BURLINGTON DEVELOPMENT REVIEW BOARD

Tuesday, January 4, 2022, 5:00 PM

MEMORANDUM

To: Development Review Board
From: Mary O'Neil, AICP, Principal Planner
Date: January 4, 2022
RE: ZP21-762 22 Park Street

SCALE: 3/16" = 1'-0

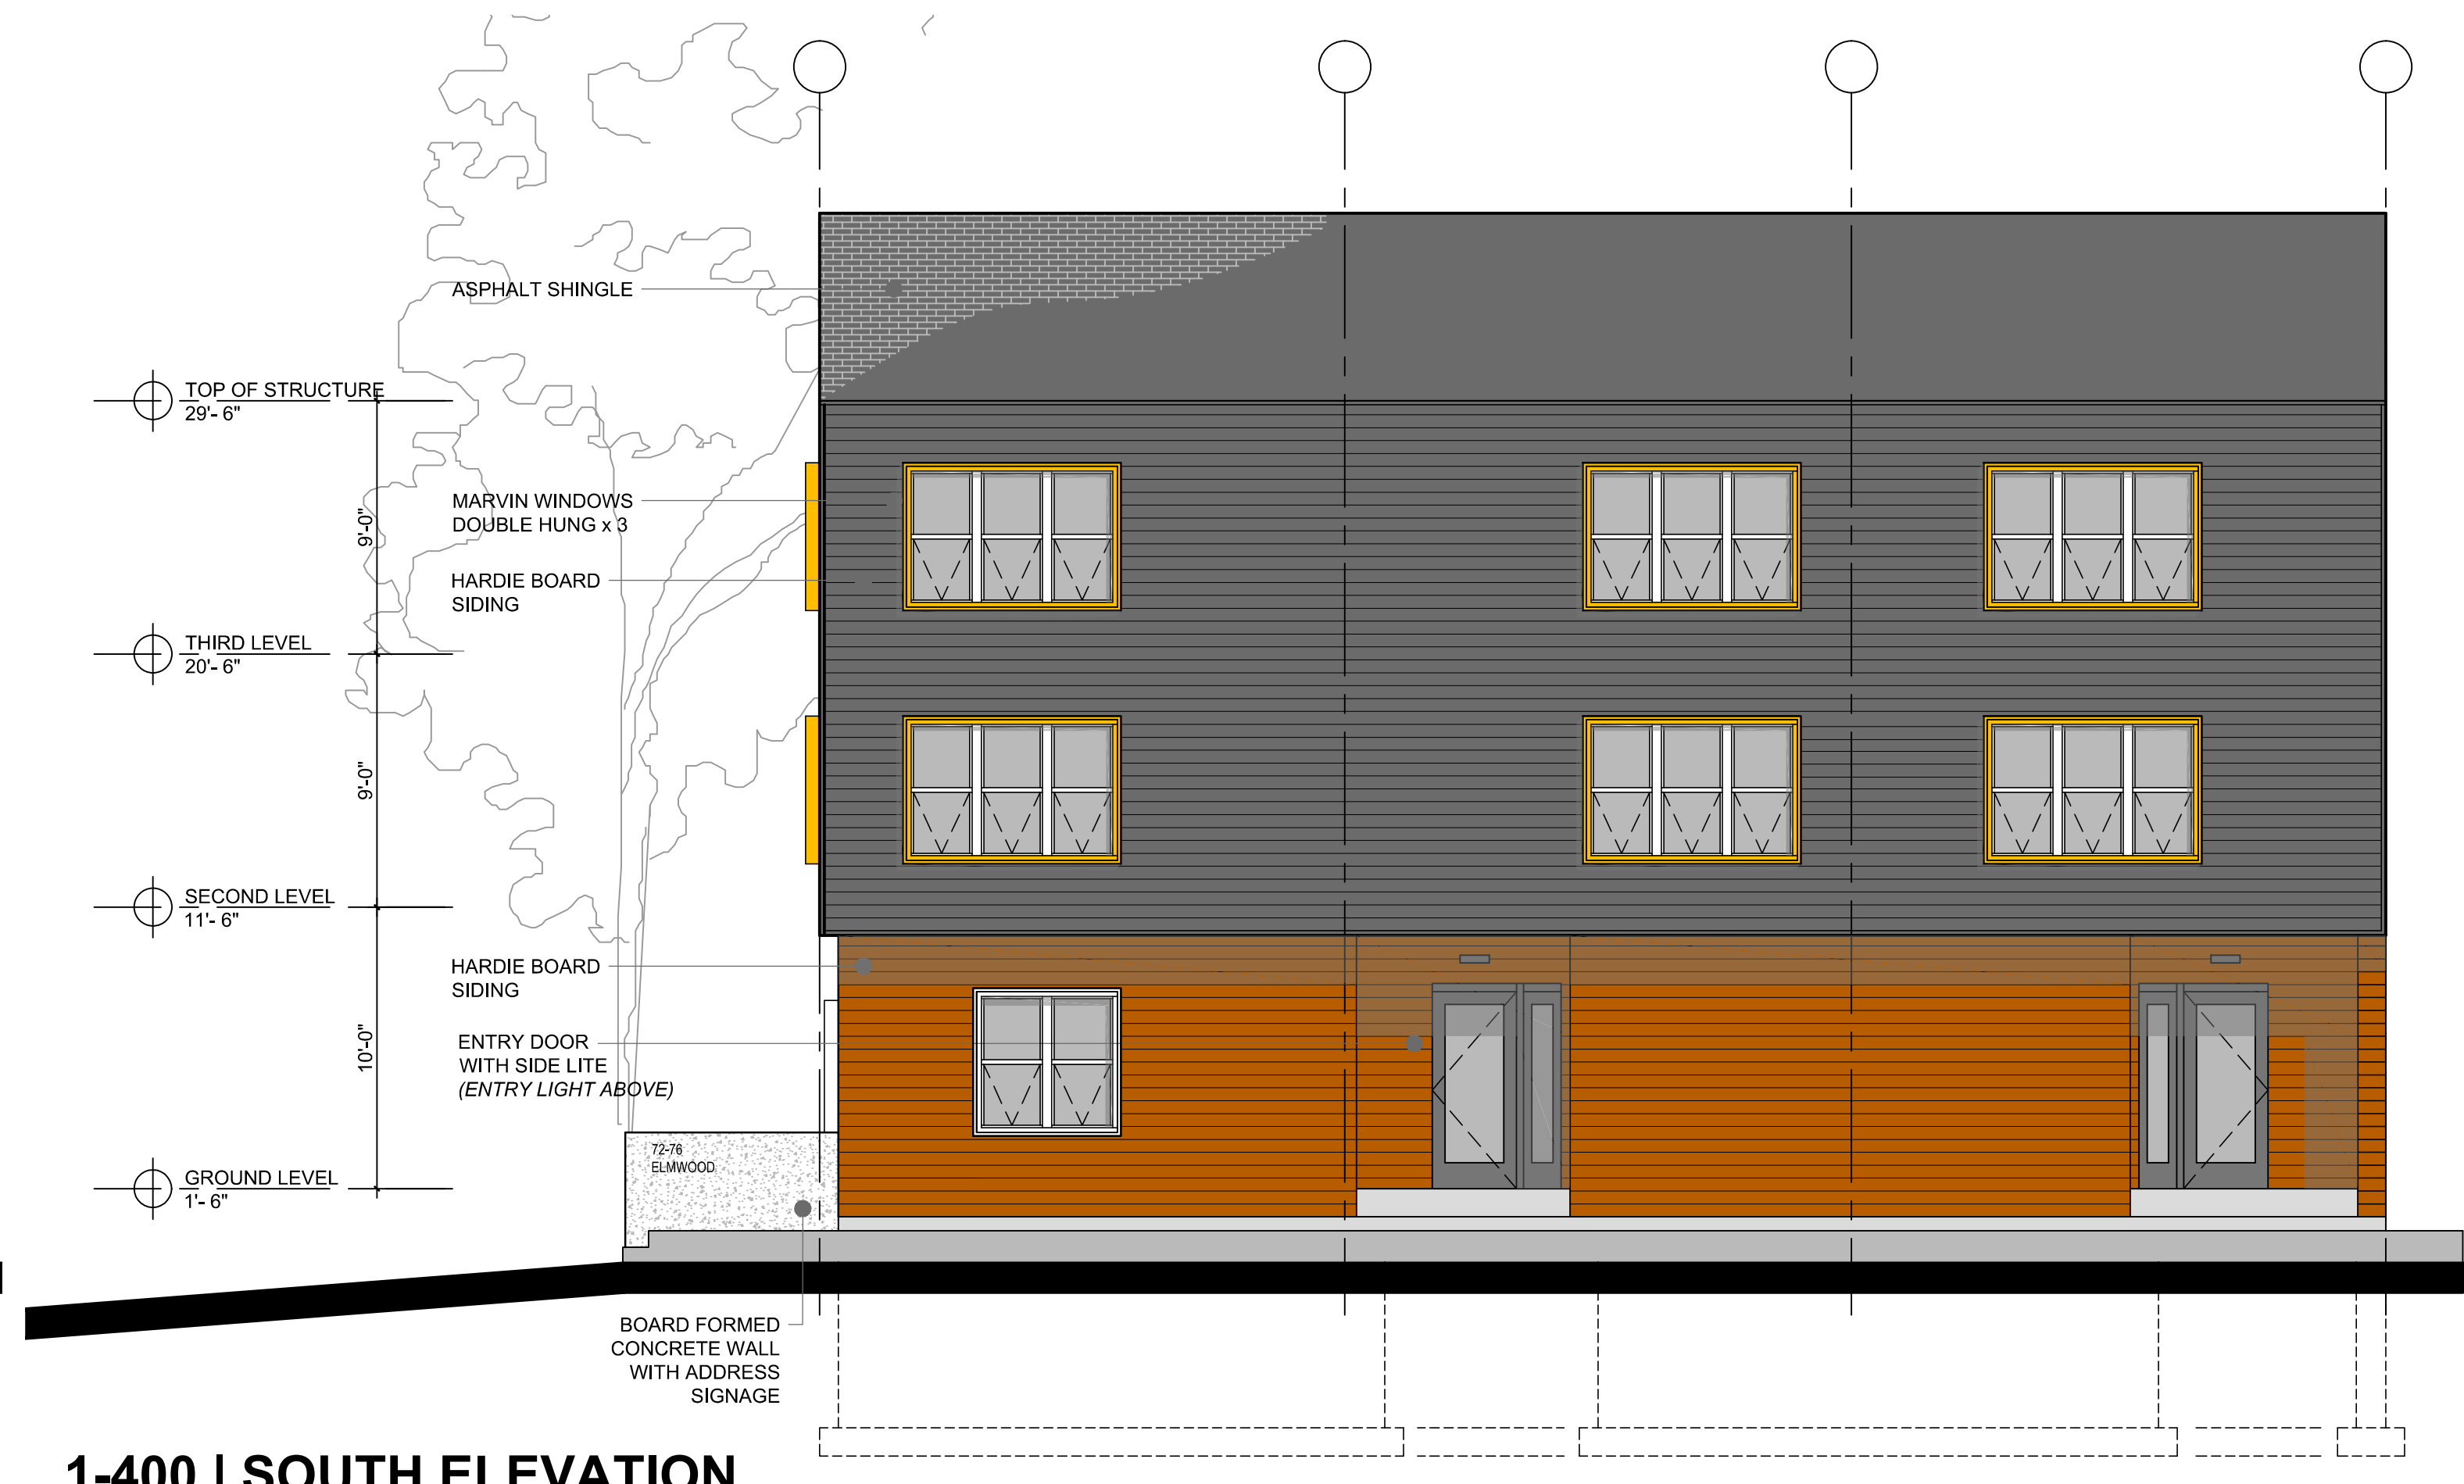
The proposed building has a modified cat-slide roof with dual pitch and minimal eave extrusion. Responding to DAB comments, snow guards and rain gutters have been added on the north and south elevations. In style it reads as a modern infill. **Affirmative finding.**

As designed, the building lacks typical façade articulation such as bays, horizontal and vertical façade articulation, porches, patios, articulated bases, step-backs or other street level details. Upon the recommendation of the DAB, a change in plane and color has been introduced between the first and second floor. Windows are stacked, providing a measure of arrangement. The plan is modernistic with a simplified form and measured detailing. The most prominent design component is the angular and asymmetrical roof line, and “framed” window surrounds. Revisions include a differentiated first floor south and west entry, as requested by the Design Advisory Board. **Affirmative finding.**

Plans include fiber cement siding, with metal frame surrounds on windows and an asphalt shingle roof. All are considered acceptable for new construction. **Affirmative finding.**
